Access Compliance Report Public Rights-of-Way (Curb Ramps)

Intersection ID: 25664 Main Street: WALSH BV **Cross Street: JOHNSTON_RD** Location: SE ADA ID: 0043265446A3 Ramp Type: PerpDiag Initial Pass/Fail: Fail **Overall Compliance: No** Severity Score: 13.75

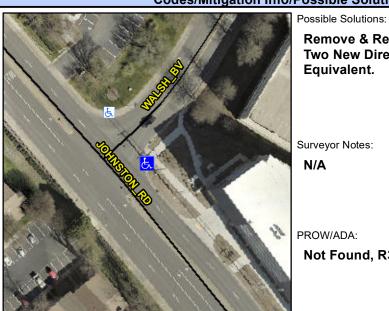
Not Found, R304.2.2, R304.5.3

Field Measurements/Component Compliance						
	Compliance Description		Data	Comp	liance Description	Data
	N/A	Ramp Length (in)	57.0	No	Ramp Slope (%)	8.6
	Yes	Ramp Width (in)	48.0	No	Ramp XSlope (%)	4.5
	N/A	Flare Type LT	N/A	N/A	Flare Type RT	N/A
	N/A	Flare Slope LT (%)	N/A	N/A	Flare Slope RT (%)	N/A
	N/A	Flare Traversable LT?	N/A	N/A	Flare Traversable RT?	N/A
	N/A	Landing Length (in)	N/A	N/A	DWS Provided?	N/A
	N/A	Landing Width (in)	N/A	N/A	DWS Contrast?	N/A
	N/A	Landing Slope (%)	N/A	N/A	DWS Length (in)	N/A
	N/A	Landing X Slope (%)	N/A	N/A	DWS Full Width?	N/A
	N/A	Landing Curb? (Y/N)	N/A	N/A	DWS Offset (in)	N/A
	N/A	Shared Landing?	N/A			
	N/A	Gutter Ponding?	N/A	N/A	Gutter Slope (%)	N/A
	N/A	Gutter Lip Ht (in)	N/A	N/A	Gutter X Slope (%)	N/A
	N/A	Painted X Walk1?	No	N/A	Painted X Walk2?	No
		X Walk 1 Direction	To NW		X Walk 2 Direction	To SW
	N/A	X Walk 1 Width (in)	N/A	N/A	X Walk 2 Width (in)	N/A
		X Walk 1 Slope (%)	0.3		X Walk 2 Slope (%)	8.1

X Walk 1 X Slope (%)	6.1		X Walk 2 X Slope (%)	4.0
	N/A	Ramp inside XWalk1?	N/A	N/A	Ramp inside XWalk2?	N/A
		Road Slope (%)	4.8	N/A	Clear Space?	N/A
		Road X Slope (%)	6.5	N/A	Clear Space to XWalk (in)	N/A
	N/A	Any Obstructions?	N/A	N/A	Storm Grate/Utility Hazard?	N/A
		Obstruction Type			Storm Grate/Utility Type	
			N/A			N/A
				Yes	Surface Condition? (G/P)	Good

Remove & Replace Curb Ramp With **Two New Directional Ramps or** Equivalent.
